Rebuttal Expert Report

RIVER TRAINING STRUCTURES AND OTHER METHODS TO
REASONABLY IMPROVE THE NAVIGABILITY OF THE RIO GRANDE
BETWEEN RIVER MILES 275.5 AND 610.0

MICHAEL D CHAPMAN P.E., U.S. ARMY CORPS OF ENGINEERS

Figure 7: Width of Falcon Lake over 17.6 miles

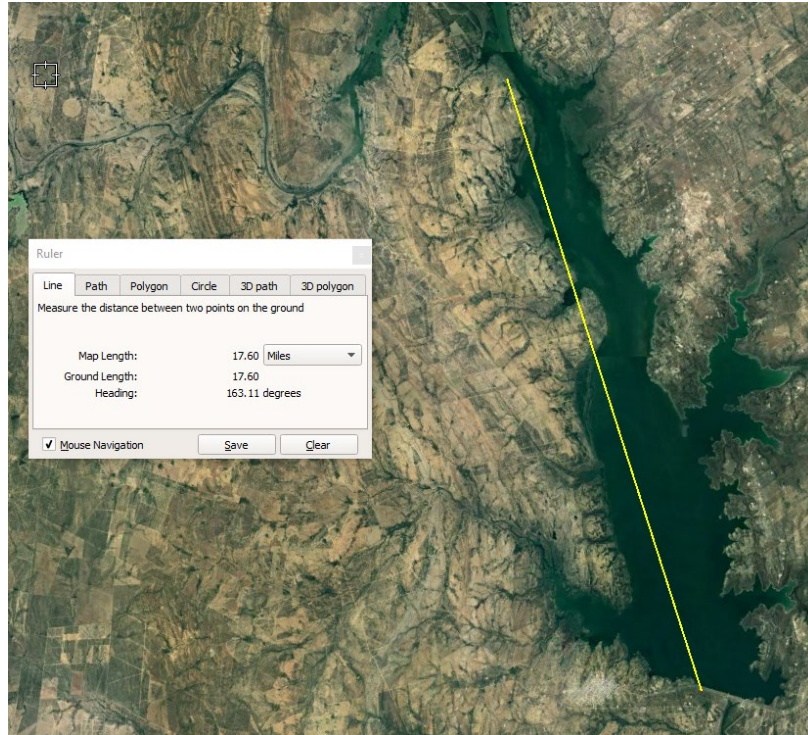
In Table 6 Dr. Shields then calculates evaporative water losses for water surface area increases due to the construction of locks and dams and compares the losses to the 10th percentile of flow² at Laredo. Dr. Shields calculates evaporative water losses for a range of assumed widths due to locks and dams (Table 6). Dr. Shields does not state what increase factor he used to arrive at his statement that "Lockage and evaporation would require 99% of the water....". However, if we subtract his stated 27% for lockage water needs from the 99%, we arrive at 72% due to evaporative losses. Comparing this value to Table 6 shows that a surface area increase factor of 5 corresponds to 71.7% of the 10th percentile of flows at Laredo. A factor of 5 means the width of the river would increase to 1,800 feet over its entire length³. However, the width of the river upstream of a lock and dam diminishes in width as the river rises in elevation. This is similar to the decreasing width of Falcon Lake in the upstream direction (Figure 7). For reference, Falcon Lake has a pool height of 100 feet (Taylor, page 14) above the river immediately downstream.

A review of transect profiles in Google Earth Pro (Appendix D for examples) indicates that 1,200 feet is about the maximum inundated width if a lock and dam raised the water surface 20 feet as proposed by Taylor (Taylor, page 14). Considering 1,200 feet is the maximum width, an increase factor of 3 is more realistic. Since the width decreases in the upstream direction⁴, the maximum increase factor of 3 should be cut in half. From Table 6, interpolating for a factor of 1.5, evaporative losses would equal 40% of the 10th percentile of flow at Laredo.

Adding the above evaporative and lockage water losses, the total worse case water need is 40% plus 17.5% or 57.5% of the 10th percentile of flows at Laredo. This indicates that there is sufficient water in the system to account for lockage and evaporative water losses more than 90% of the time (with water left over for consumptive uses) and that water supply is not a limiting factor for the proposed system of locks and dams. This result disagrees with Dr. Shields statement that “the amount of water needed to address losses due to evaporation and lock operation would be prohibitive” (Shields page 18).
